# Rezoning Transportation Analysis

Petition Number: 2017-118

General Location Identifier: 04115106

**Reviewer: Eric Lemieux, PE**

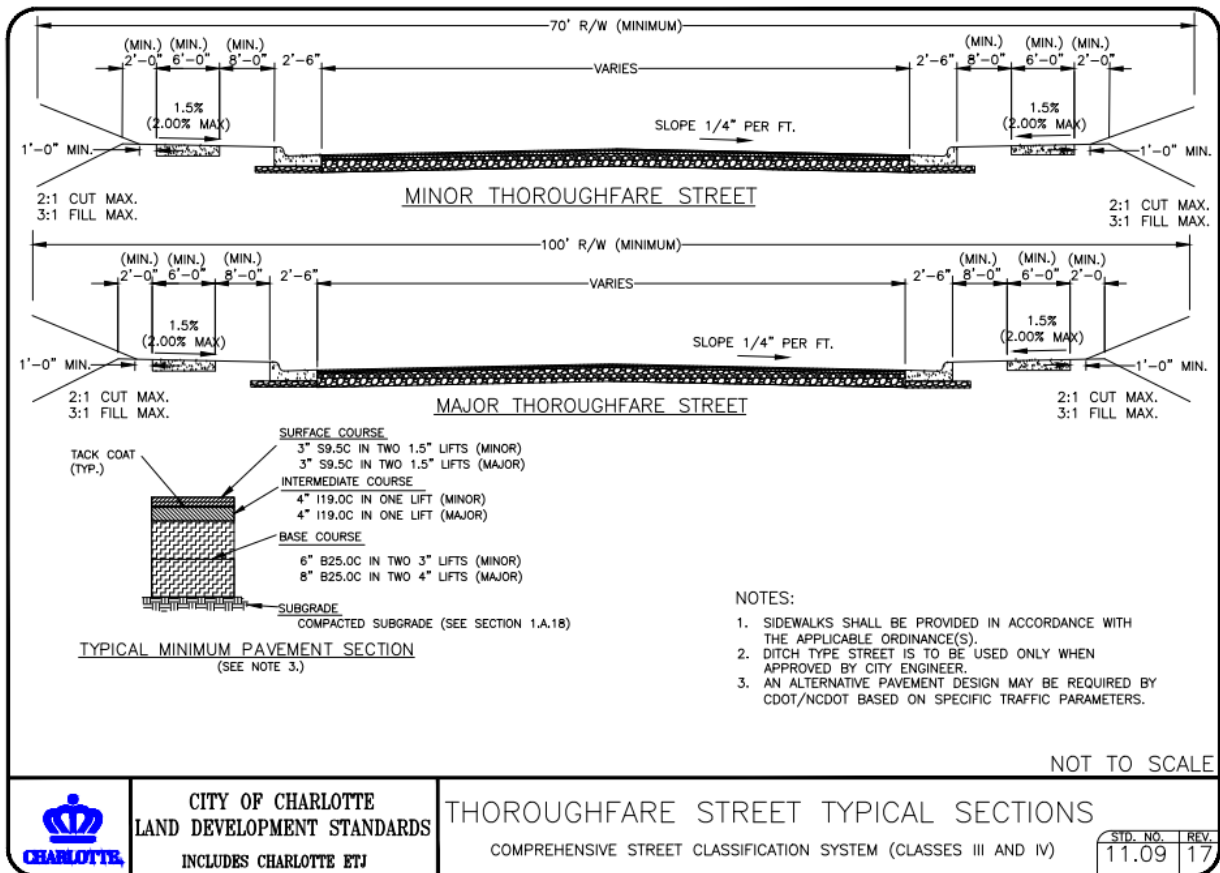
- Outstanding Comment (site plan dated 05/11/20)** If large trees are removed, the petitioner should reconstruct to an 8' planting strip and 6' sidewalk along frontage, as required by Chapter 19 of the City Code. The proposed planting strip must be a minimum of 8' in width. The 6' sidewalk may meander around the existing trees, if contained within a sidewalk-utility-easement, which is to be placed 2' from the proposed back-of-sidewalk. The planting strip must be installed between the existing back of curb and proposed sidewalk. Refer to the additional design references provided below.

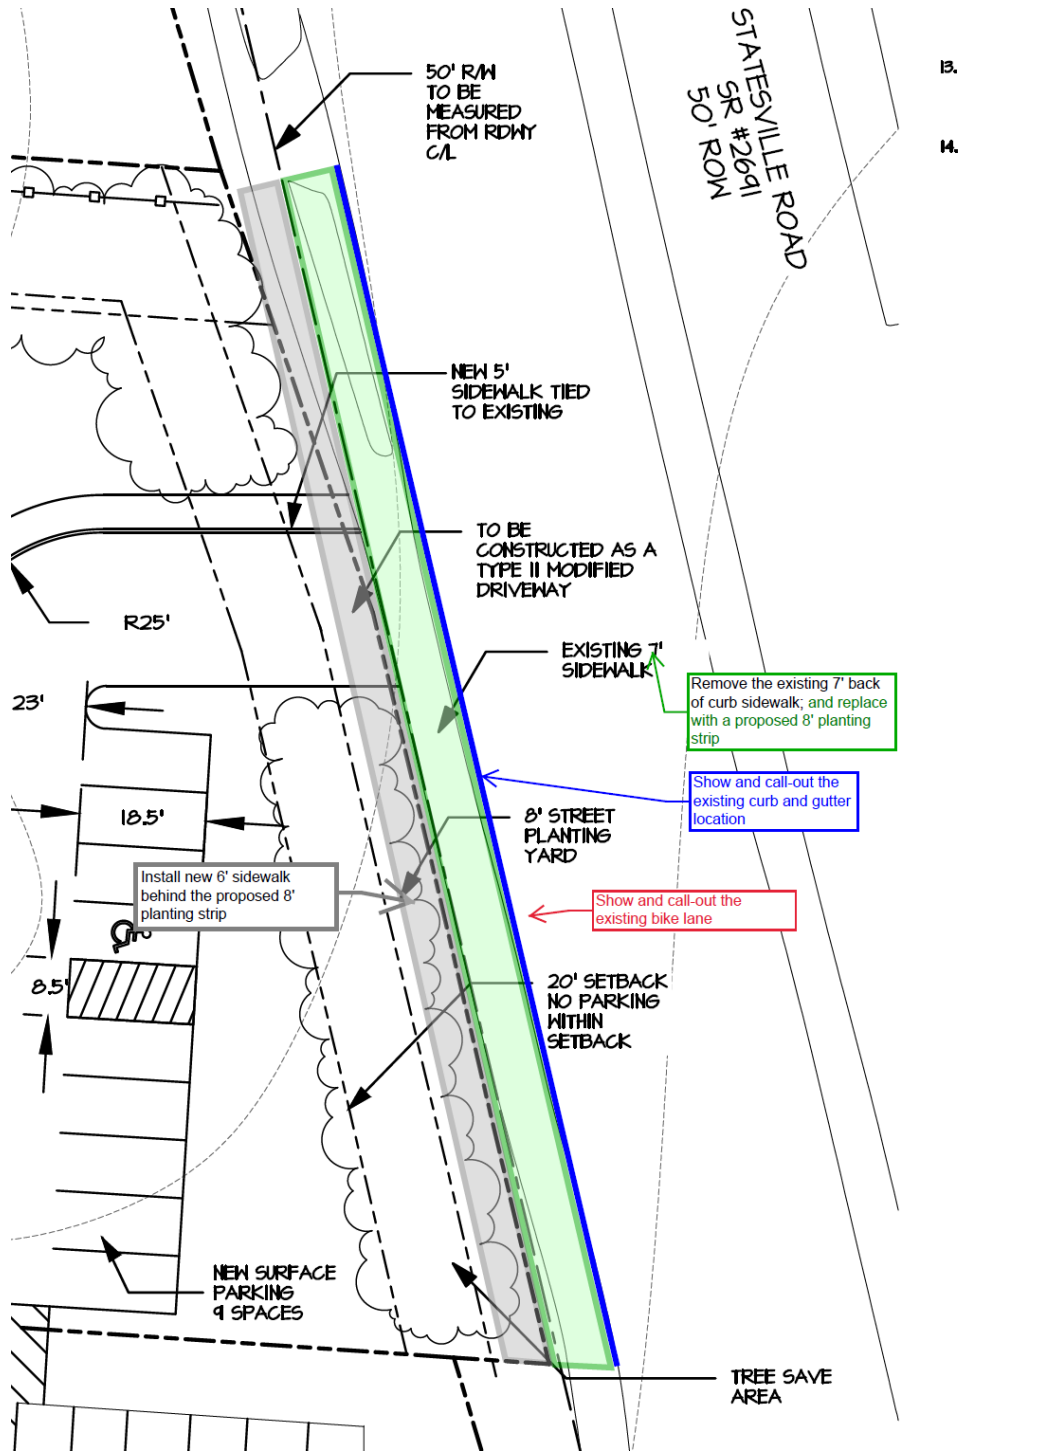
4. **Outstanding Comment (site plan dated 05/11/20)** Revise the site plan to dimension the proposed right of way dedication from the Statesville Road centerline. **Additional design guidance is provided below.**
